UNITED STATES PATENT AND TRADEMARK OFFICE

APPLICATION NO.	FILING DATE	FIRST NAMED INVENTOR	ATTORNEY DOCKET NO.	CONFIRMATION NO.
10/085,649	02/26/2002	Andrew J. Whitton	091395-9214 (4596-TC-AU)	8642

Office Action Summary

DETAILED ACTION

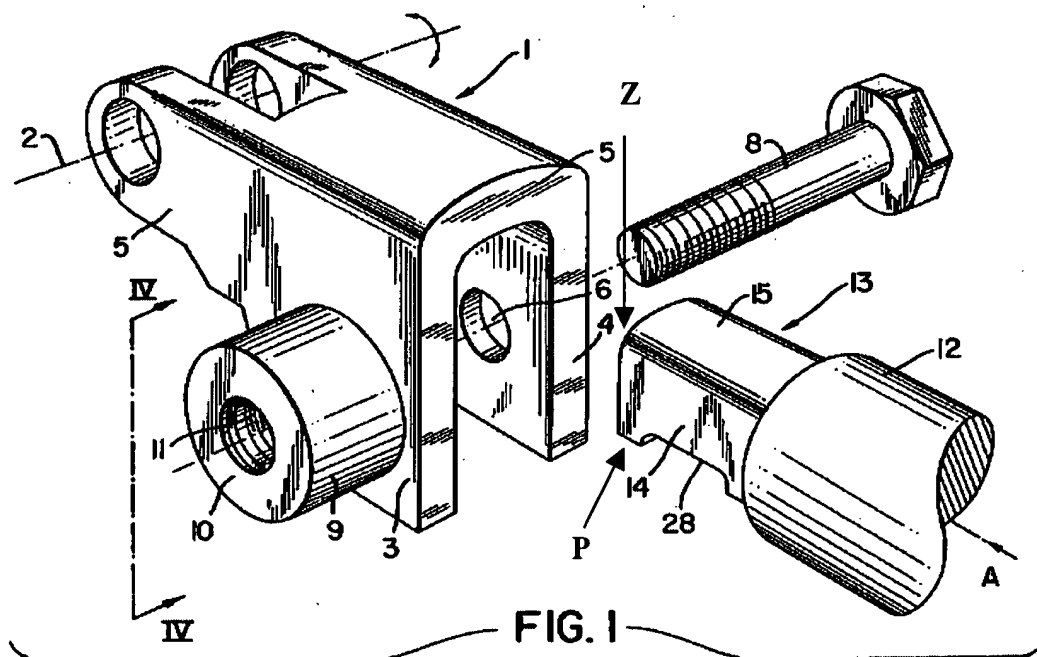
a. Claim 1. Oertle shows and discloses a shaft **12** configured for interconnection with a coupling element **1**, the shaft **12** comprising an axial shaft body having upper and

lower surfaces and terminating in a forward end **Z**; a bolt receiving recess **28** in the upper shaft surface adjacent the forward shaft end **Z**; and the shaft body forward end **Z** having a substantially planar surface except for at least one projection **P** extending from the shaft forward end **Z**, the at least one projection **P** having an upper surface contiguous with the upper shaft surface and positioned completely within an upper hemisphere of the shaft body (see annotated figure 1 below).

- b. Claim 2. Oertle further shows the shaft body **12** having a given cross-sectional area and the projection **P** having a cross-sectional area substantially less than the shaft body **12** cross-sectional area (see annotated figure 1 above).
- c. Claim 9. Oertle shows a shaft coupling assembly comprising a coupling element **1** including a shaft-receiving slot (created inside element **5**) having a bottom surface and

d. Claim 10. Oertle further shows the shaft-receiving slot having a given cross-sectional area, the shaft body 12 having a cross-sectional area (that of section 13 of the shaft 12) substantially equal to the shaft-receiving slot cross-sectional area and the projection P having a cross-sectional area substantially less than the shaft-receiving slot 9 cross-sectional area (see annotated figure 1 above).

- e. Claims 7 and 17. Oertle further shows the bolt receiving recess **28** being a notch (see annotated figure 1 above).
